ADDENDUM # 002

**Our Lady of Fatima
545 Baldoon Rd
Chatham, ON**

New Exterior Wall Assembly, Universal Washroom and In-coming Water Service Project No. 619-CP1835

June 4th. 2018

DRAWING TITLE
PARTIAL GROUND FLOOR PLANS - NORTH
WEST AND NORTH EAST
LIGHTING AND FIRE ALARM

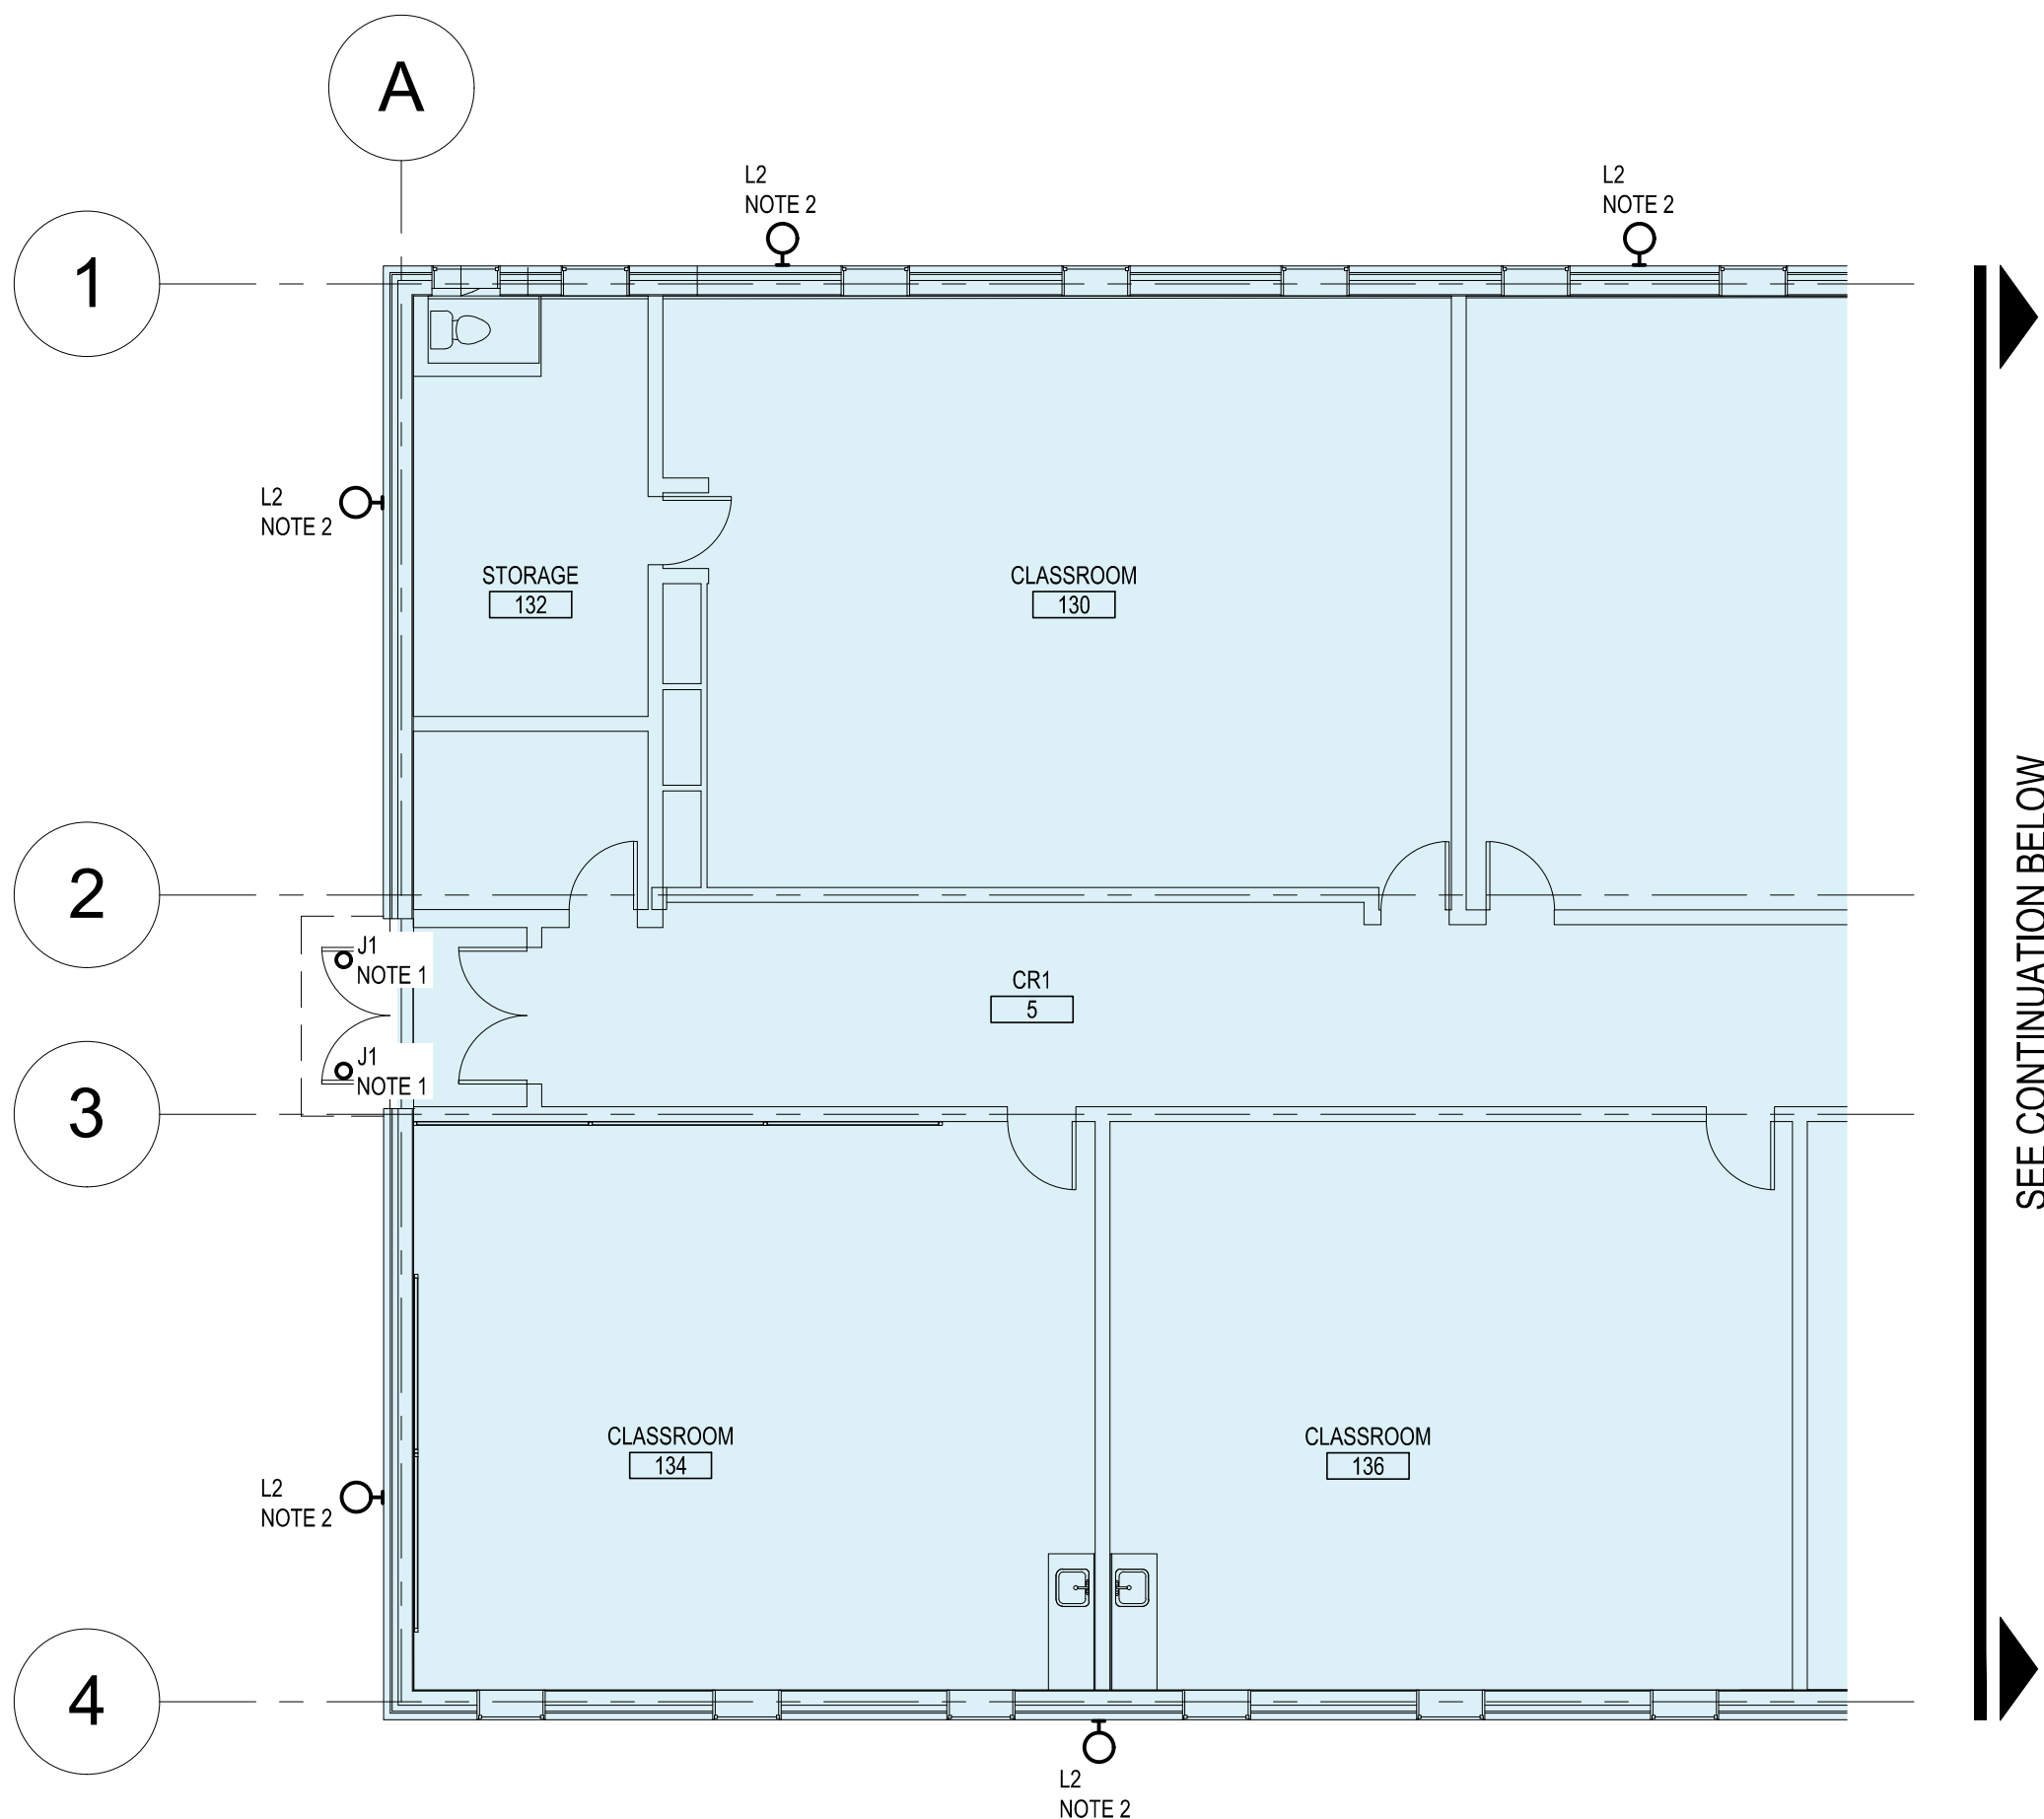
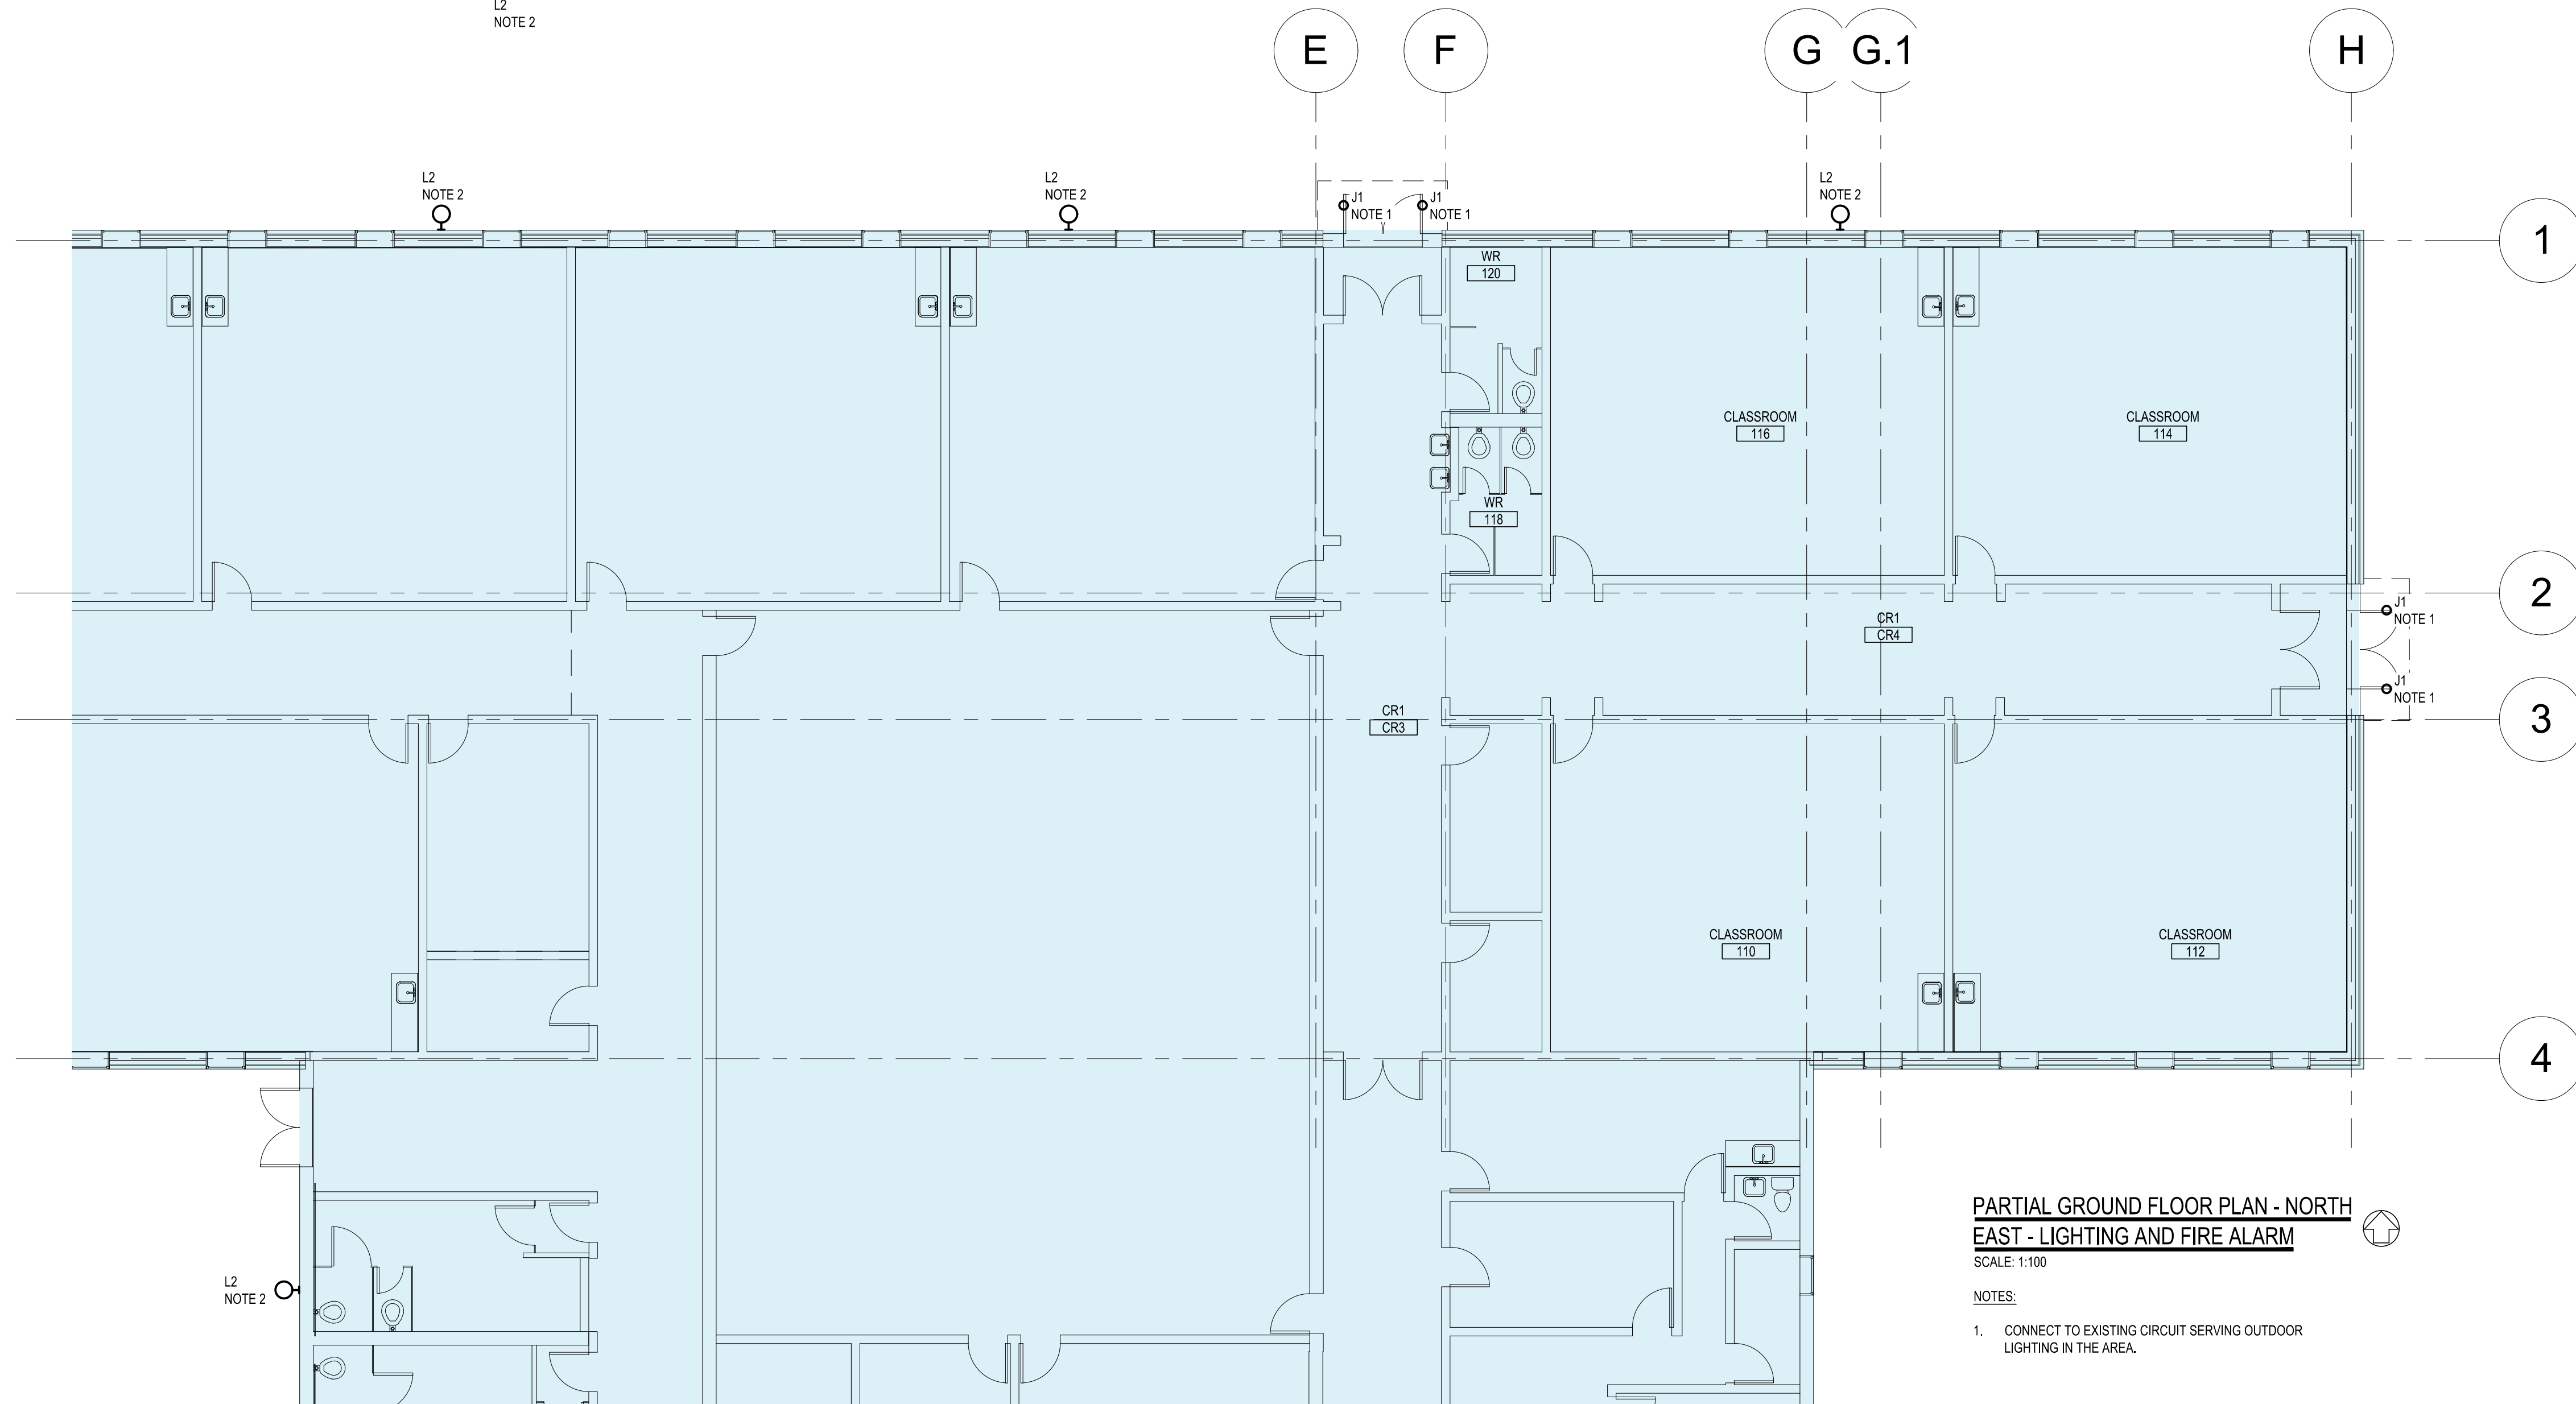
Electrical Drawing E201 – Partial Ground Floor Plans – North West and North East Lighting and Fire Alarm

ASK-010

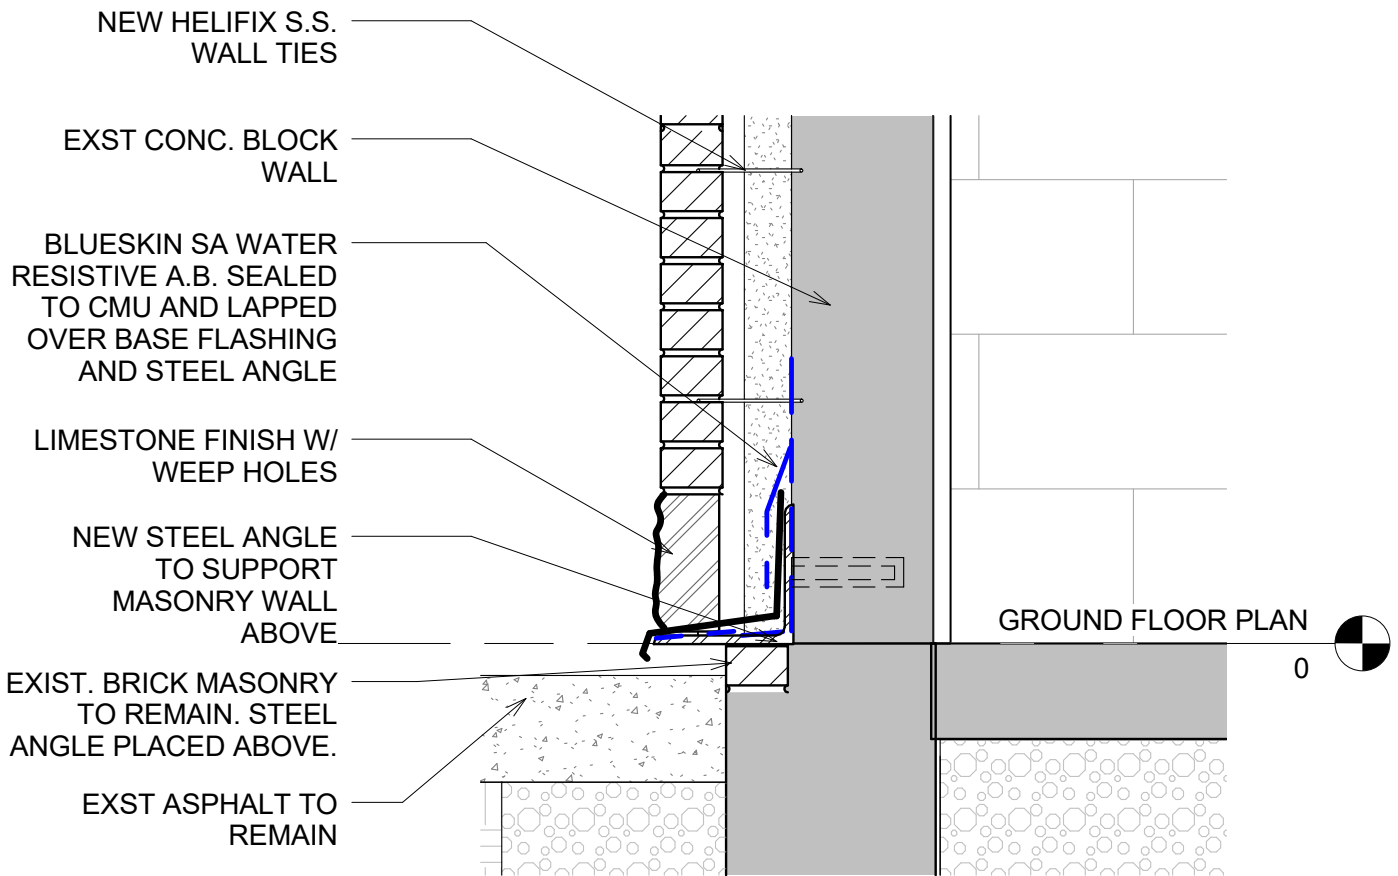
ASK-010 – Reinstall Existing Wall Accessories/Hardware:

A100 – Reinstall existing hose connect with extensions, gas lines and electrical outlets in existing locations after applying new wall finishes.

REINSTALL
HOSE BIB CONNECT
WITH EXTENSION

REINSTALL FENCE POST

REINSTALL SECTION OF
FENCE IN NEW LOCATION
TO ACCOUNT FOR NEW
MASONRY WALL FINISH

REINSTALL FENCE POST
IN NEW LOCATION TO
ACCOMMODATE
FOR NEW MASONRY WALL
FINISH

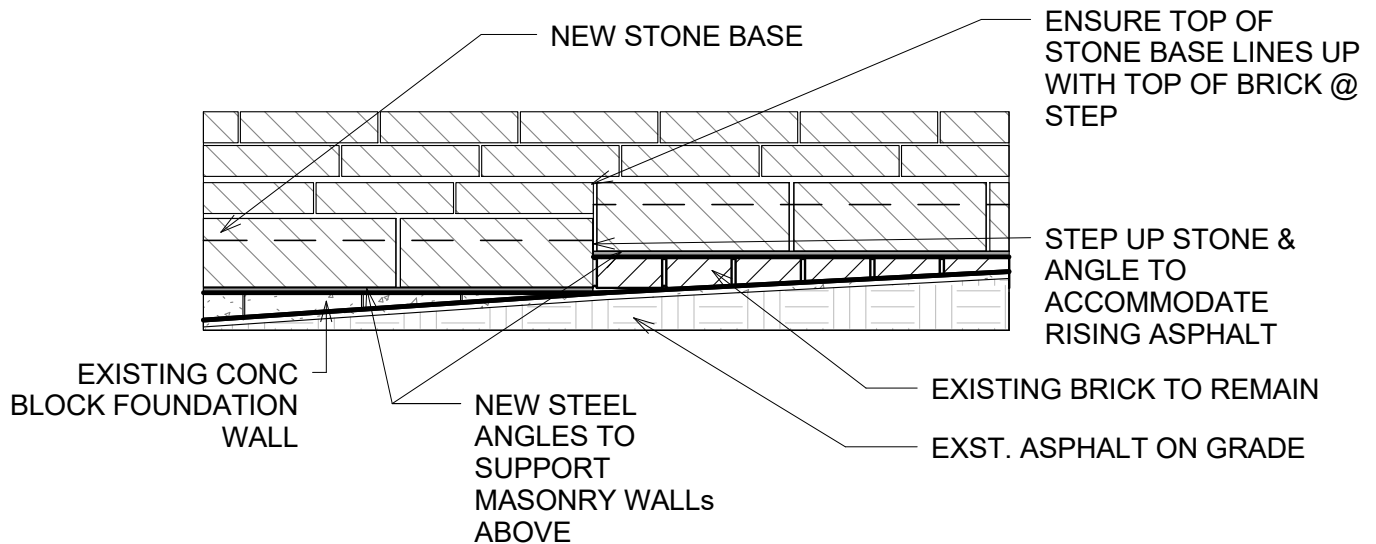
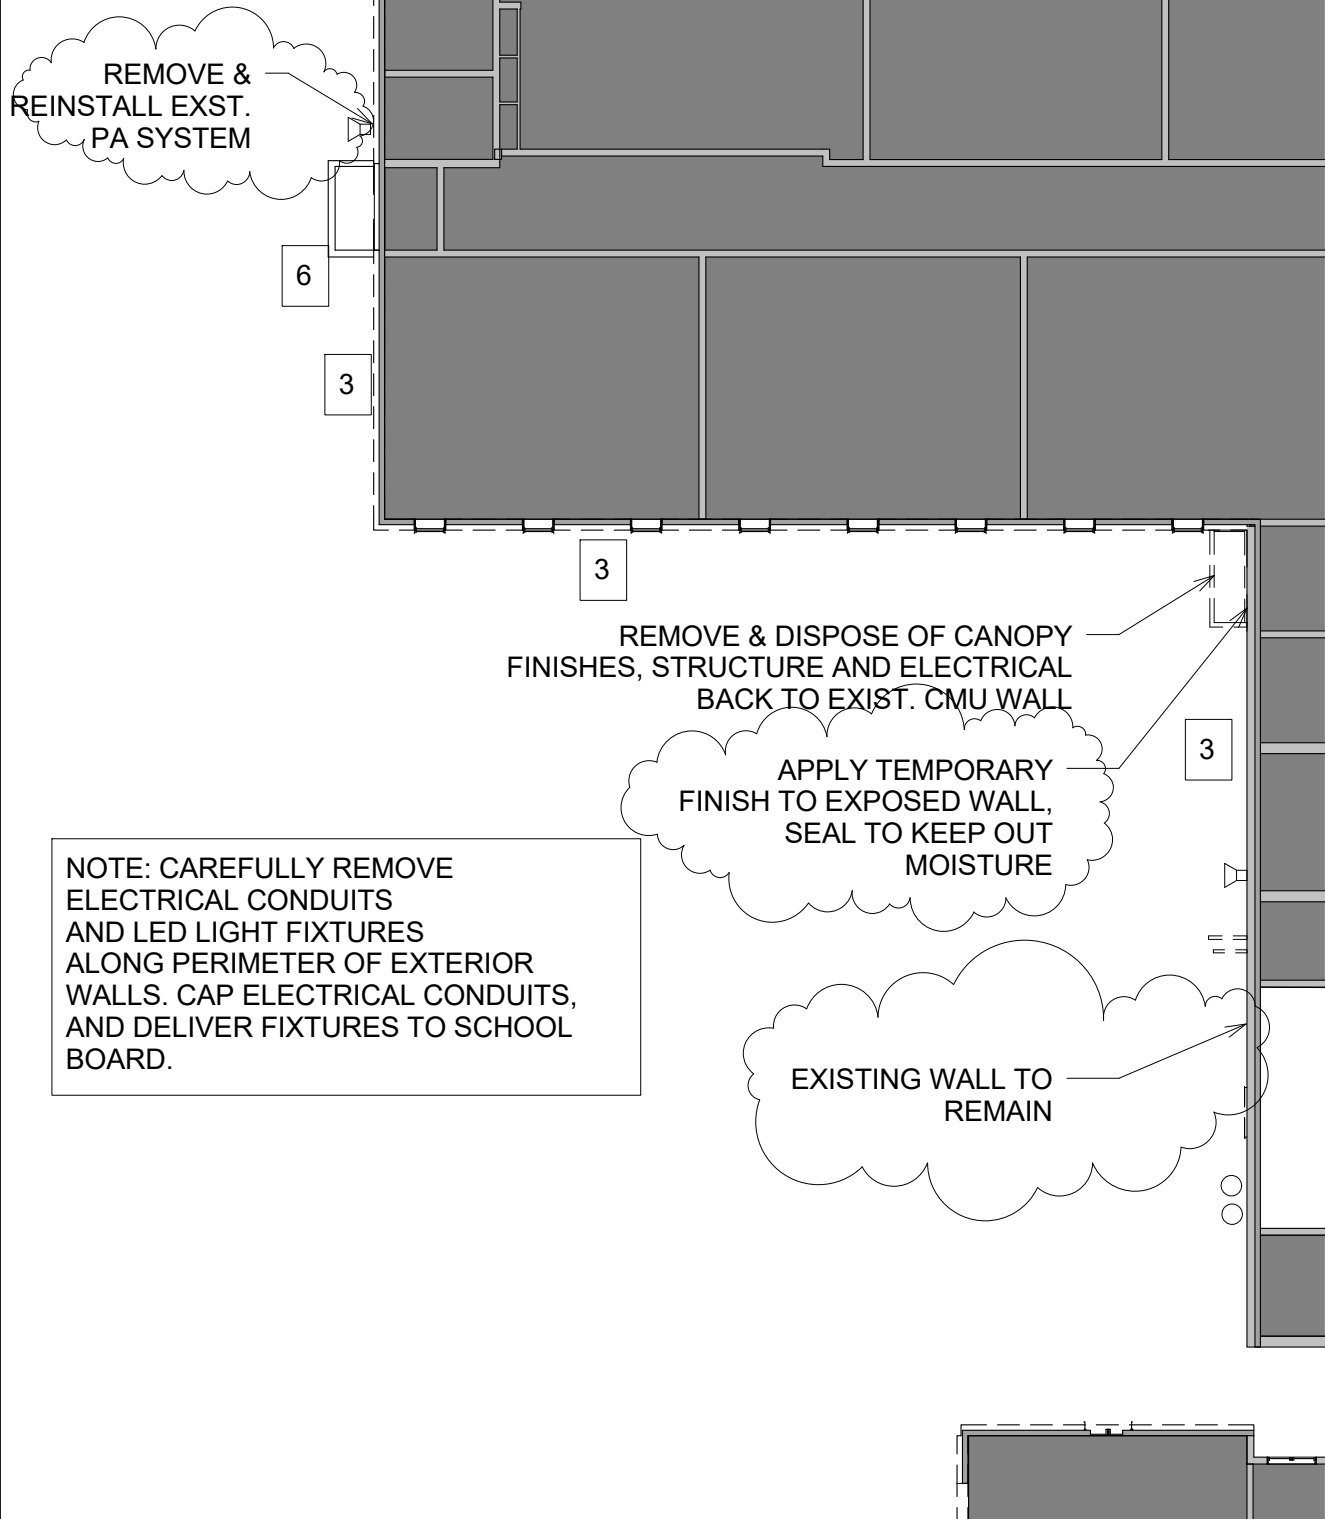
ASK-011 – Detail at West Wall Base:

A675 – New wall section and base detail illustrating the treatment of foundation wall and new masonry support angle. Some of the existing brick is set underneath the existing asphalt. This brick is to remain, and the new masonry support angle is to sit on top of this brick. No asphalt cutting required. Where asphalt rises above existing brick, step up angle to accommodate for the rise.
